Value Engineering Study Report

*Georgia Department of Transportation
CSSTP-0006-00(857)(866) – P.I. No. 0006857 and 0006866
Widening and Reconstruction of SR 92
Cobb and Paulding Counties*

RE: Submittal of the final Value Engineering Report
Project No.: **CSSTP-0006-00(857)(866) – P.I. No. 0006857 and 0006866**
Widening and Reconstruction of SR 92
Cobb and Paulding Counties

ALTERNATIVE NO.:
RD-1

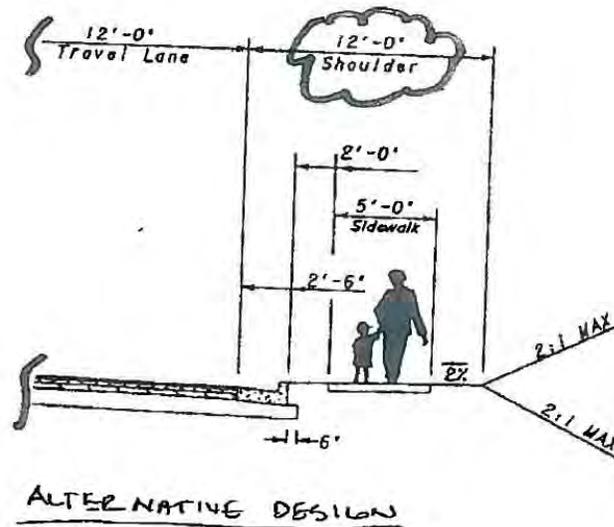
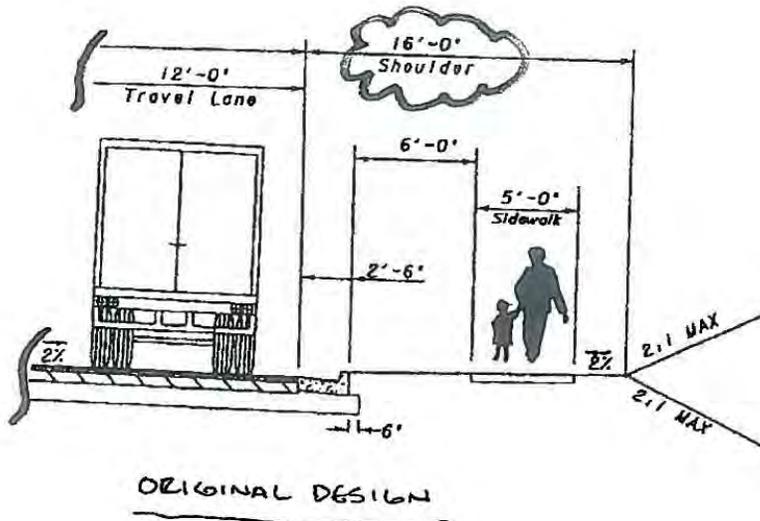
The original design calls for the construction of 16' shoulders in either direction throughout the project.

The alternative proposes constructing 12' shoulders in either direction throughout the project.

The alternative proposes constructing 12' shoulders in both directions of the proposed roadway, in lieu of the as-designed 16' shoulders. The alternative will have the effect of reducing 4' of ROW required in each direction by narrowing the shoulders. All of the proposed design elements will remain on the alternative shoulders (i.e. 5' sidewalk). Identified risks include a possible reduction in width for staging during construction, which would need to be developed as the project plans progress.

ALTERNATIVE NO.:
RD-3

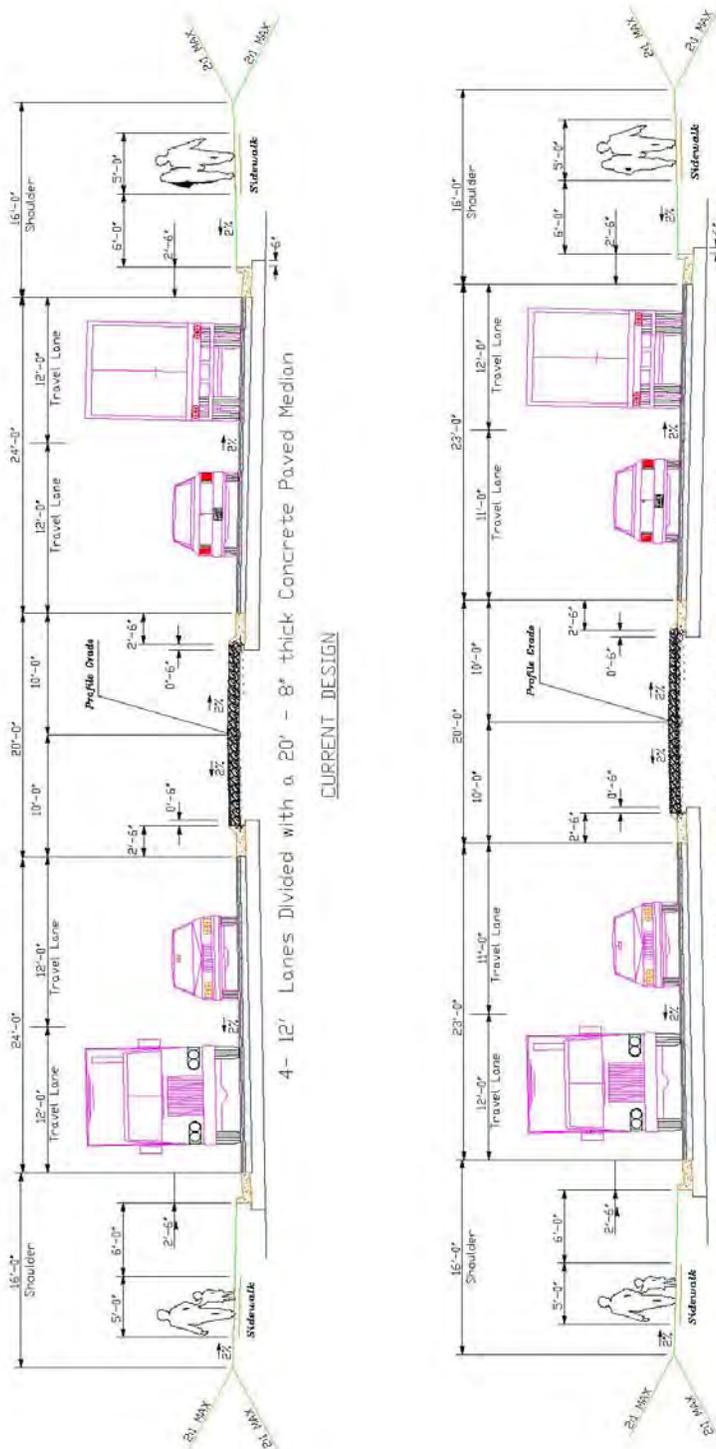
The original design proposes construction of two 12' travel lanes eastbound and westbound throughout the project.

The alternative proposes constructing a 12' outside travel lane, as well as an 11' inside travel lane throughout the project.

Reduction of width of travel lanes throughout the project would result in 2' of full build-up widening that would not have to be constructed, resulting in significant cost savings. AASHTO's "Policy on Geometric Design of Highways 2004" states that 11' lanes are permissible. It also states that under interrupted –flow operating conditions at low speeds (45 mph or less), narrower lanes are normally adequate and have some advantages. (See Pages 472-473). The combination would construct 12' outside lanes to accommodate the local truck traffic, as well as allowing a greater turn radius to right-turning vehicles.

ALTERNATIVE NO.:
RD-5

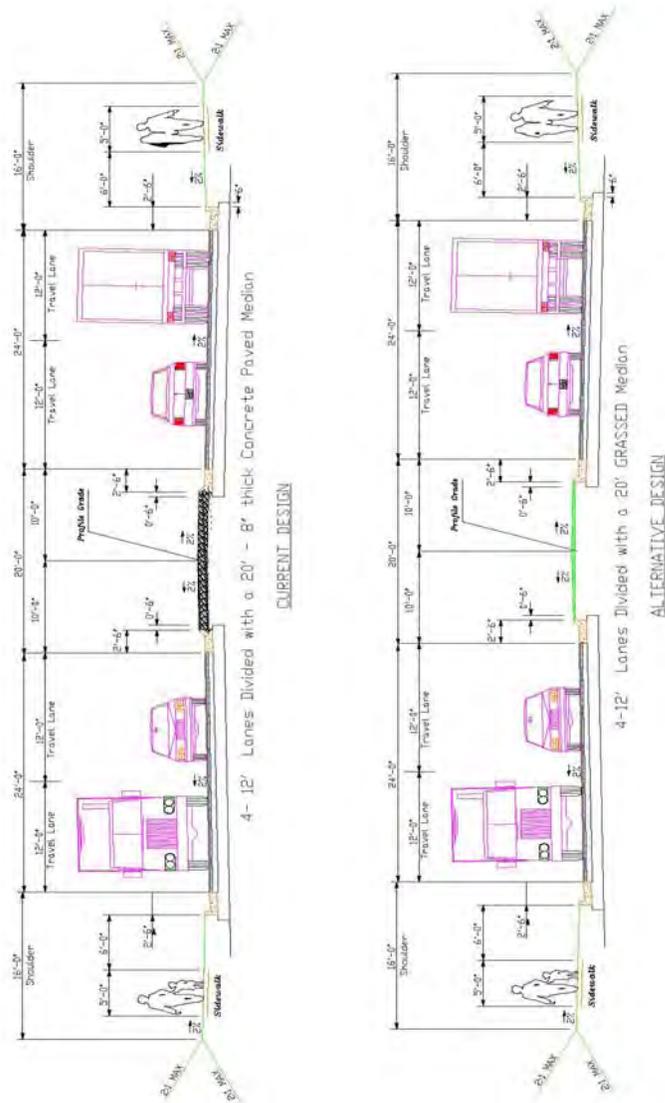
The original design proposes a 20' raised concrete median to be constructed throughout the project.

The alternative proposes construction of the raised median interior with earth, with a grassed surface in lieu of the proposed 8" concrete paved surface.

The intent of the alternative is to replace the 20' raised concrete median, and replace it with an earth-filled, grassed final surface in the raised median. The alternative would remove the proposed 8" concrete median, resulting in huge initial project savings. The alternative would require maintenance agreements for Paulding and Cobb Counties to maintain their respective portions throughout the project following its completion. In the concept report, a Summary of Meeting minutes from April 8, 2008, contained a statement from a representative from Cobb DOT requesting a grassed median, and indicating that Cobb County would maintain the grassed areas, as well as pay for upgrades for plantings. If Paulding County would reciprocate on the maintenance for their portion, the cost savings would be great.

ALTERNATIVE NO.:
RD-6

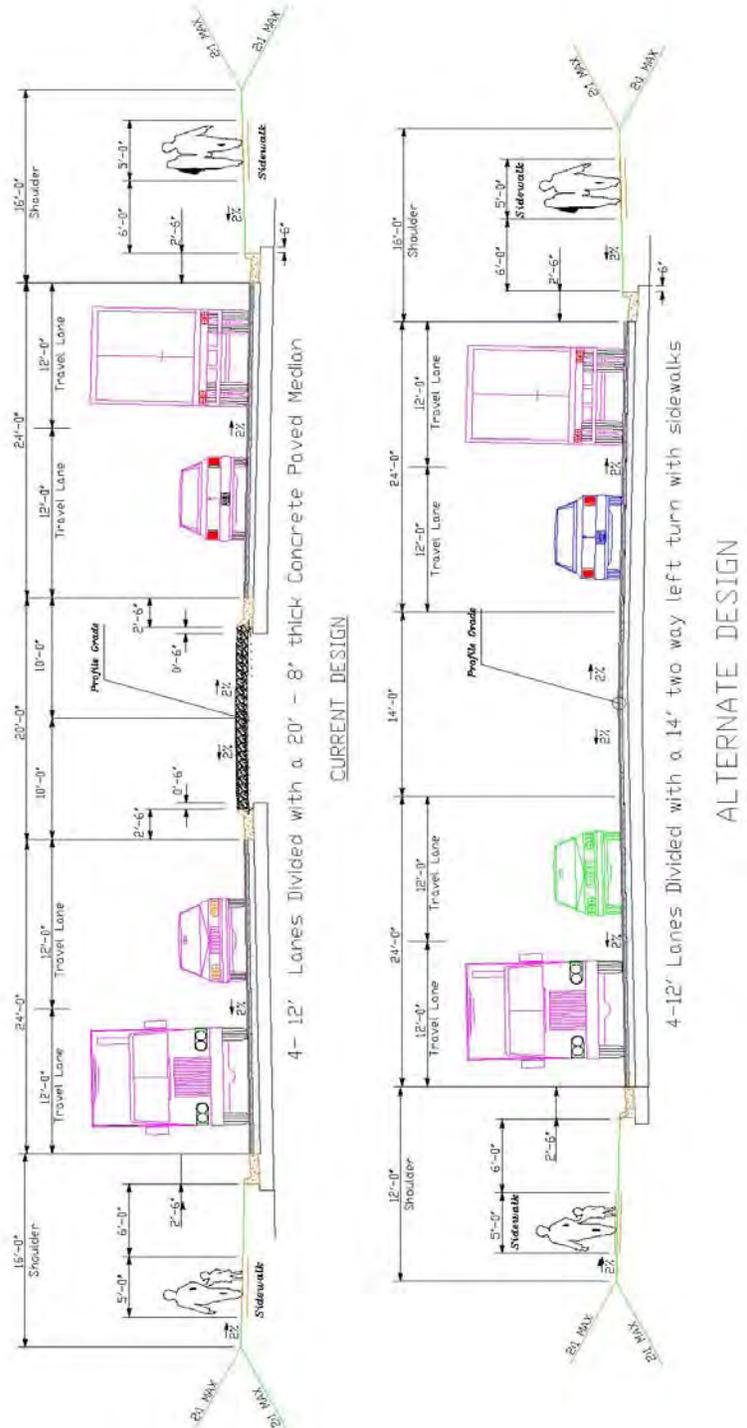
The original design provides four 12' lanes and a 20' raised median.

The alternative design is to construct a five lane section with four 12' lanes a 14' flush median.

The use of five lane section will significantly reduce costs and ease the construction. The design year AADT is 35,960 vpd with 15.5 % trucks and this would generally make a five lane section less desirable. However, this roadway's access points are primarily public roads or "well spaced" entrances to major developments with relatively few minor driveways.

ALTERNATIVE NO.:
RD-10

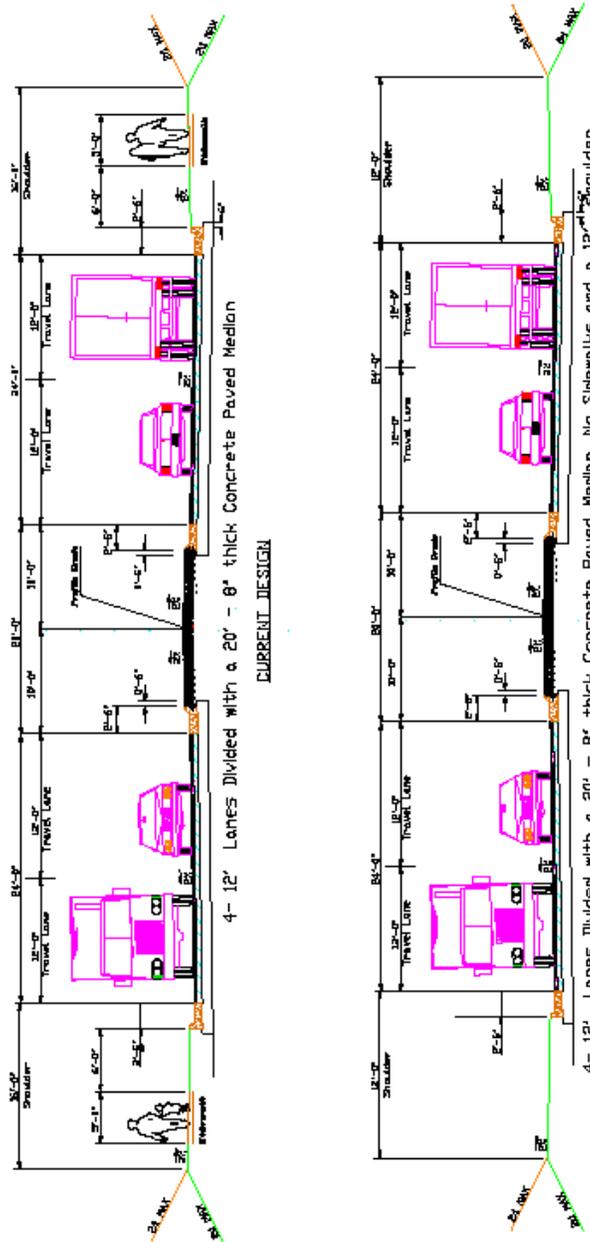
The original design calls for construction of a 5' sidewalk in both directions throughout the project.

The alternative would eliminate the sidewalk in selected areas where it appears the pedestrian demand would be minimal on the project.

The alternative would remove the proposed sidewalk from STA 318+00 to STA 250+00, and reduce the shoulder width in these areas from 16' to 12'. The intent of the alternative is to identify areas on the project where pedestrian demand may be limited. The areas identified begin at approximately STA 250+00 and continue east to the project terminus at US 41/Cobb Parkway. Although these areas appear to be in a moderately concentrated residential area, the alternative keeps the sidewalk in the areas of the schools on the project, as well as the commercial development at the beginning of the project on Cedar Crest Road. Further analysis may yield additional areas where the utility of sidewalk construction on the project is marginal, and further cost savings may be realized.

ALTERNATIVE NO.:
RD-13

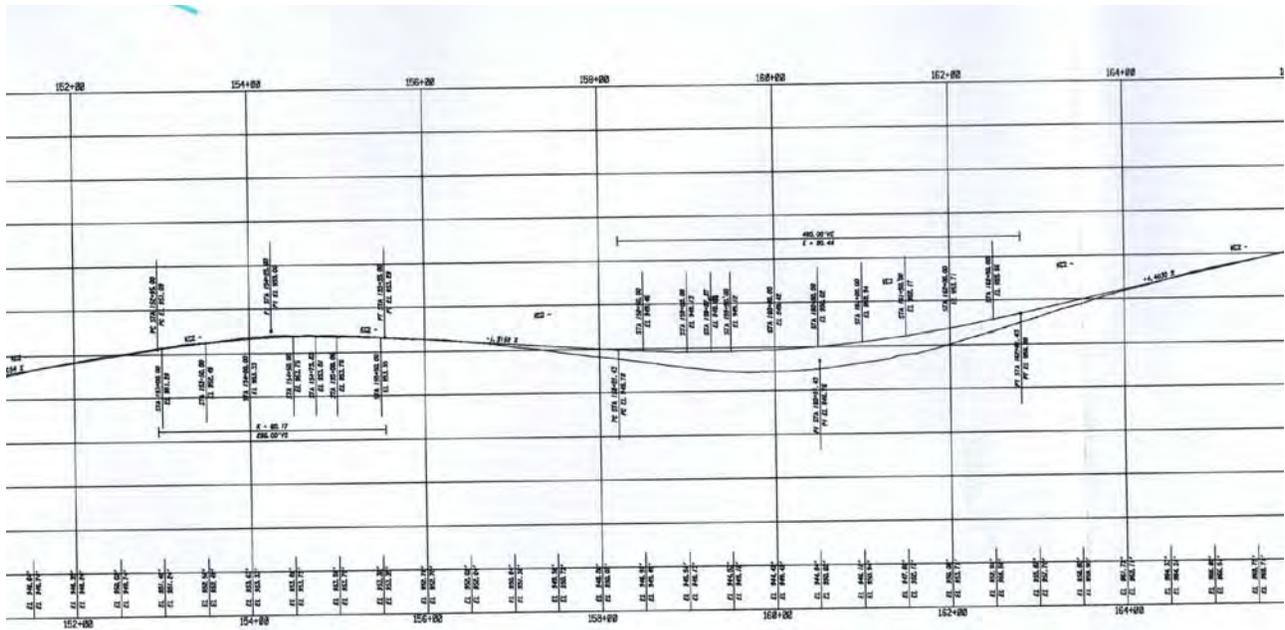
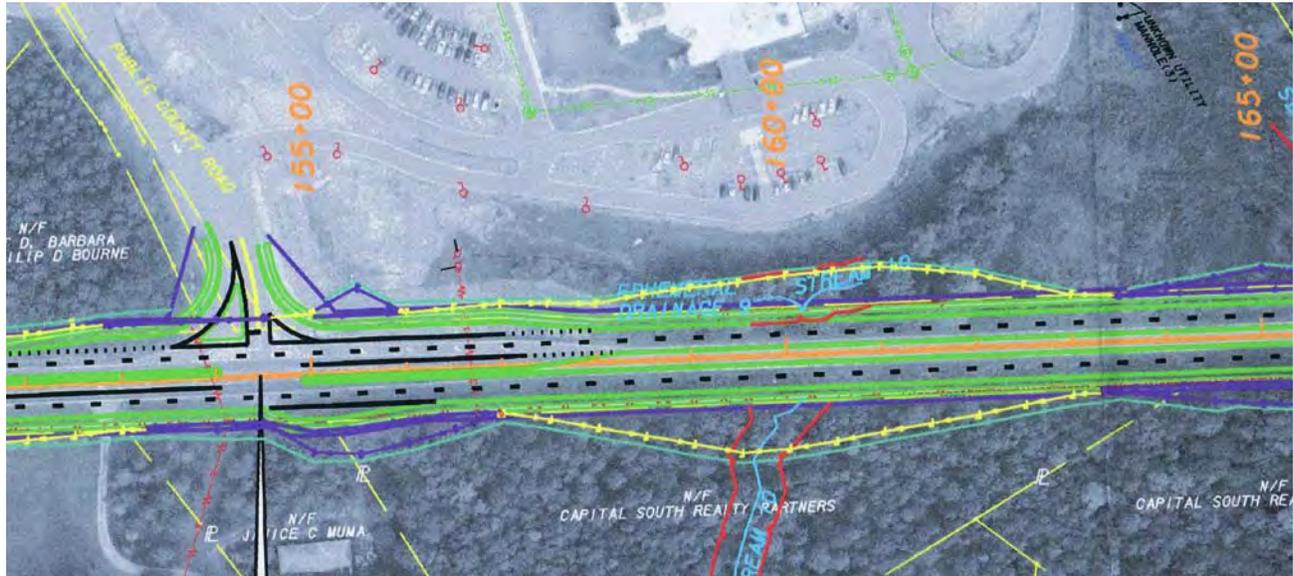
PROJECT:	Georgia Department of Transportation CSSTP-0006-00(857)(866) P.I. No. 0006857 and 0006866 Widening and Reconstruction of SR 92 Cobb and Paulding County	ALTERNATIVE NO.:	RD-13
DESCRIPTION:	Obtain a design exception in-lieu of a sag vertical correction at Station 160+51.43	SHEET NO.:	4 of 4

ALTERNATIVE NO.:
RD-24

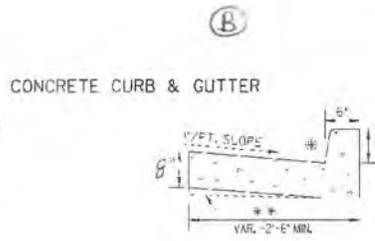
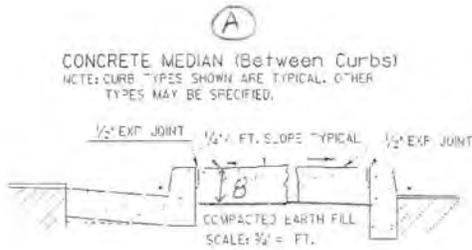
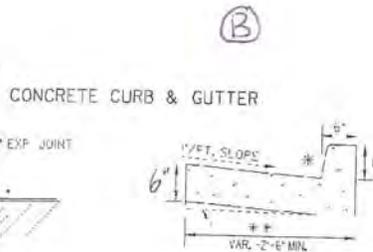
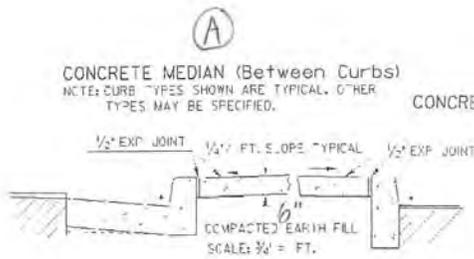
PROJECT:	Georgia Department of Transportation CSSTP-0006-00-(857)(866) – P.I. No. 0006857 and 0006866 Widening and Reconstruction of SR 92 Cobb and Paulding Counties	ALTERNATIVE NO.:	RD-24
DESCRIPTION:	Use 6” concrete median, 6” valley gutter, and 30” combo curb and gutter at 6” height.	SHEET NO.:	1 of 4
